Re: Garvies Point – PUD Amendment and Blocks D, E & F Site Plan Review,  
Response to Saratoga Associates Memo Dated 04/15/2021

This letter will serve as a response to the 04/15/2021 memo provided by Saratoga Associates regarding the PUD Master Plan Amendment and Blocks D, E, & F Site Plan Submission.

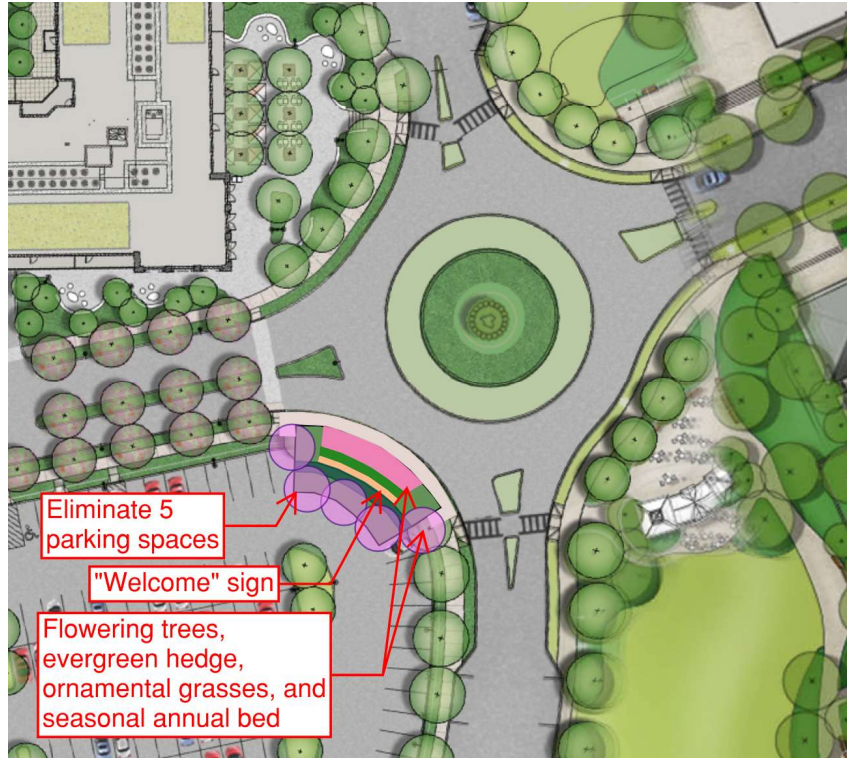
11. SA had noted that the trees proposed within the Block D parking lot and along the streetscape are all deciduous, resulting in minimal screening in winter months. As the parking lot is raised above the proposed hedge, vehicles will be visible from the street. SA suggested that the applicant include a shrub buffer along the portions of the parking lot that front the roadway to ensure screening of parked cars and headlights. While this has not been added, Section 3 on revised L-501 depicts a hedge tall enough to screen car headlights (taller in section than in Detail 2/L-605). The Board should decide whether they would like additional plantings along the streetscape edges of the parking lot. SA recommends that further consideration be given to the landscaping and aesthetics at least in the northeast corner of Lot D, near of the rotary. If approximately 6 parking spaces were converted to a landscaped area, this could improve the view from the rotary, which acts as a gateway within the project. The Board would need to decide whether additional landscaping would outweigh the loss of public parking spaces for the Ferry and other uses.

In response to the discussion held with SA and the City on 05/07/21, five parking spaces are proposed to be replaced with a sign and plantings at the NE corner of Block D. This will be further detailed in the revised submission. See diagram below for illustrative purposes.
